Ford Fiesta, from 08/95 – 01/01/99 Engine code ST to XC

Coolant temperature display is constantly close to the red zone

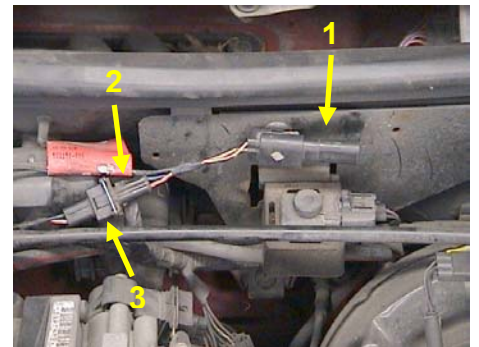
If there are complaints about the above-mentioned fault, the cause could be the coolant temperature sensor. Although the engine temperature is within the normal range, it is possible that at high outside temperatures the sensor sends an incorrect value to the gauge. This fault can be eliminated by installing a modified sensor.

To replace the sensor, proceed as follows:

- Note radio code and any stored radio stations
- Disconnect the battery
- Disconnect the plug for coolant temperature display from the sensor
- Remove the sensor. Hold the housing against it when removing.
- Install the new sensor and tighten to 8 Nm
- Detach the sensor plug from the cable, insulate the cable ends and secure these to the cable loom
- Loosen the diode (Pos. 1) with the connection cable from the bracket
- Separate the diode's plug connection (Pos. 2)
- Remove the diode with cable
- Now connect the plug (Pos. 3) directly to the sensor
- Connect the battery again
- Enter the radio code and store the stations again
